Access Compliance Report Public Rights-of-Way (Curb Ramps)

Main Street: N/A Cross Street: S_DAISSY_ST Location: W

ADA ID: RPAT220125104200 Ramp Type: Type 4 - Parallel Initial Pass/Fail: Pass Overall Compliance: No Severity Score: 22

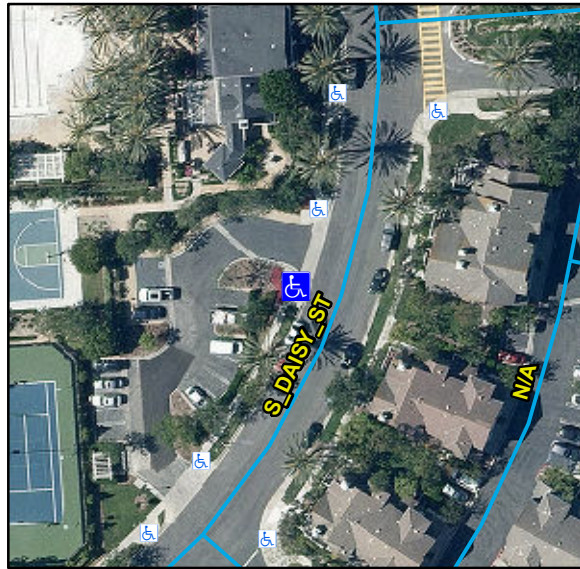
Compliance	Description	Data	Compliance	Description	Data
N/A	Ramp Length LT (in)	50	N/A	Ramp Length RT (in)	56
Yes	Ramp Width LT (in)	90	Yes	Ramp Width RT (in)	89
Yes	Ramp Run Slope LT (%)	0.2	Yes	Ramp Run Slope RT (%)	6.5
Yes	Ramp Cross Slope LT (%)	2	Yes	Ramp Cross Slope RT (%)	0.6
N/A	Landing Present	No	No	DWS Provided	No
N/A	Landing Length (in)	N/A	N/A	DWS Contrast	N/A
No	Landing Width (in)	N/A	N/A	DWS Length (in)	N/A
No	Landing Run Slope (%)	N/A	N/A	DWS Full Width	N/A
No	Landing Cross Slope (%)	N/A		DWS Offset Type	N/A
N/A	Landing Movement Obstructed?	No	N/A	DWS Offset Left (in)	N/A
	Landing Movement Type	Curb	N/A	DWS Offset Right (in)	N/A
N/A	Landing Shared	N/A			
N/A	Clear Space	N/A			
N/A	Clear Space To Crosswalk (in)	N/A			
N/A	Marked Crosswalk 1	No	N/A	Marked Crosswalk 2	N/A
	Crossing 1 Direction	NE		Crossing 2 Direction	N/A
N/A	Marked Crosswalk 1 Width (in)	N/A		Marked Crosswalk 2 Width (in)	N/A

Remove & Replace Entire Ramp.
